SPECIAL COMMITTEE OF THE WHOLE – AUGUST 31, 2010

YONGE STEELES CORRIDOR SECONDARY PLAN RESPONSE TO PUBLIC, GOVERNMENT AND AGENCY SUBMISSIONS FILE 12.5.12.4 WARD 5

Attachment 1**PART A: Index of Correspondence for PART B****Yonge Steeles Corridor Secondary Plan****Summary of Respondents' Requests/Concerns and Staff Comments and Recommendations**

Yonge Steeles Corridor Secondary Plan
SCHEDULE 4 (SOUTH)
Parks & Publicly Accessible Open Space

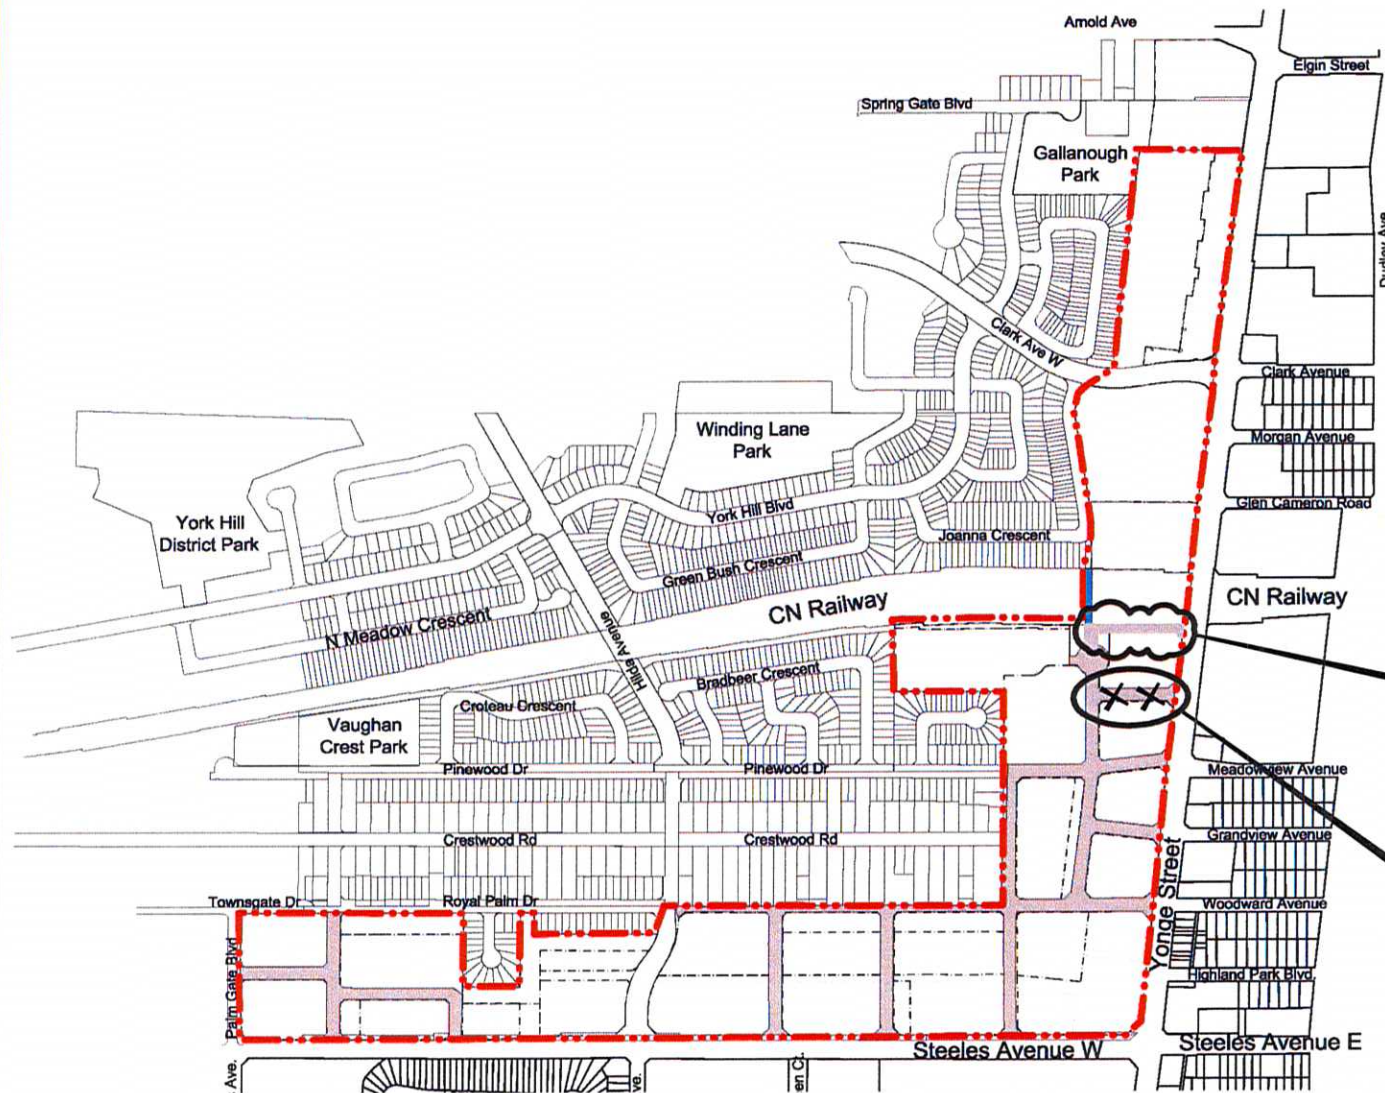
The draft Yonge Steeles Corridor Secondary Plan delineates a parks and publically accessible open space system in Attachment No. 6 that will serve the expected growing community and as an additional amenity and transitional buffer area for the existing stable low-rise residential areas. Parkland within the Yonge Steeles Corridor Secondary Plan is required to be dedicated in accordance with Section 7.3.3.2 of Volume 1 of the Official Plan, which utilizes the standard parkland conveyance provision of the Planning Act: all new residential development is required to convey parkland at the rate of 5% of the total gross land area or one hectare of parkland per 300 dwelling units, or in combination, whichever is greatest. Cash-in-lieu of parkland dedication, or a combination cash-in-lieu and parkland may also be considered. A rate of 2% is applied for non-residential and cash-in-lieu may also be considered where appropriate. Concern has been expressed by certain landowners that these standards are excessive and will be detrimental to the development of the area. The plan represents approximately half of the parkland that could be dedicated through the realization of the planned density. Cash-in-lieu of parkland dedication will be used to purchase parkland on those properties which are providing more than the parkland dedication generated by the development. The remarks from many of the land owners has emphasized the onerous nature of providing the parkland. However, the park system, when achieved will be a major asset within the immediate community and overall area; helping to ensure high land values as a result of an attractive and desirable community setting for both the existing and new communities. The connected character of the parks system supports both passive and active recreation as well as provides a linked path system throughout the community. Staff recommends no changes to the proposed parkland dedication policies which are consistent with the standards used by other municipalities in the GTA, the standards the City currently uses and it is consistent with the policies set out in draft Official Plan (Volume 1).

RECOMMENDED
 ADDITIONAL
 MANDATORY RETAIL
 FRONTAGE

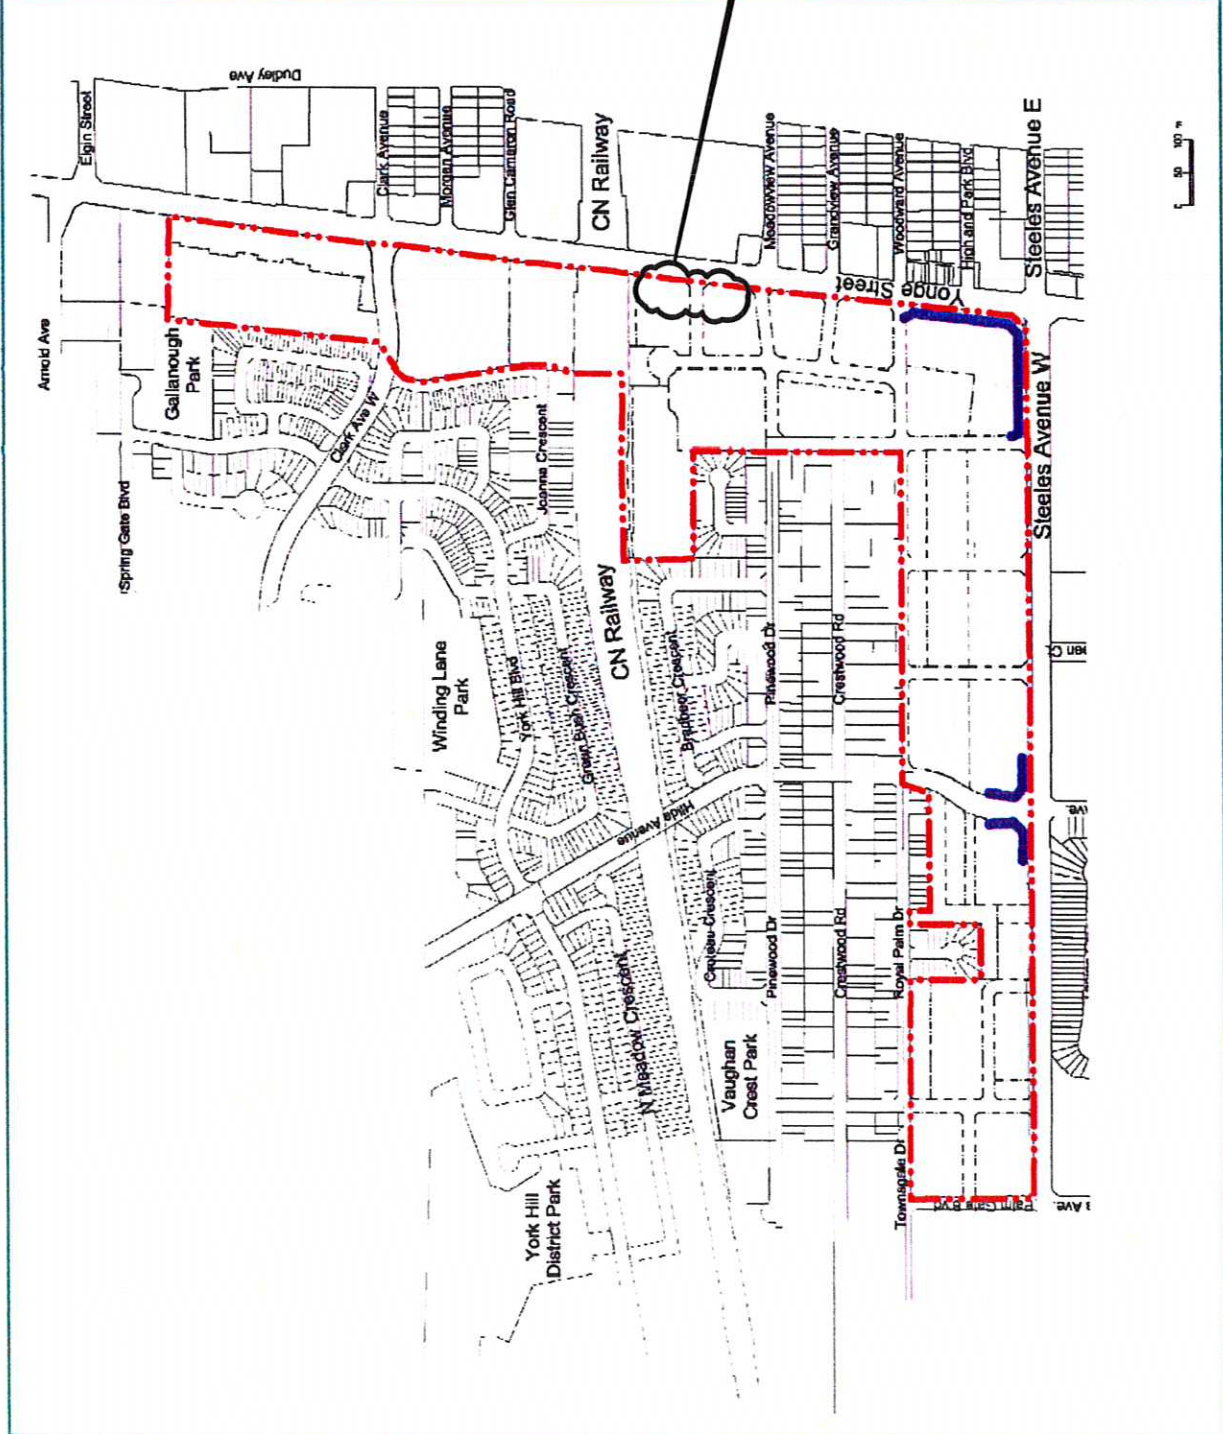
The Town of Markham has also proposed a mandatory retail frontage in the approved Town of Markham Yonge + Steeles Corridor Study (2008) that extends from south of the CN Railway to Steeles Avenue along Yonge Street. Markham has requested that Vaughan's mandatory retail requirement be similar and extend the full length of Yonge Street south of the CN Railway. However, staff questions the ability of the market to support such a large percentage of continuous retail on Yonge Street.

In light of the Town of Markham's request and in light of the approved Liberty development on the east side of Yonge Street which provides for retail uses at grade in this block, it is considered appropriate to require retail on the opposite side of Yonge Street in this location. There is an existing bus stop and a proposed fully signalized traffic light at the north portion of the Liberty site, that would provide greater opportunity for a balanced retail, pedestrian accessible environment in this area. Therefore, staff recommends that Schedule 3 (South) be amended to include mandatory retail frontage along Yonge Street from the CN Railway to the proposed easterly extension of Pinewood Drive to Yonge Street.
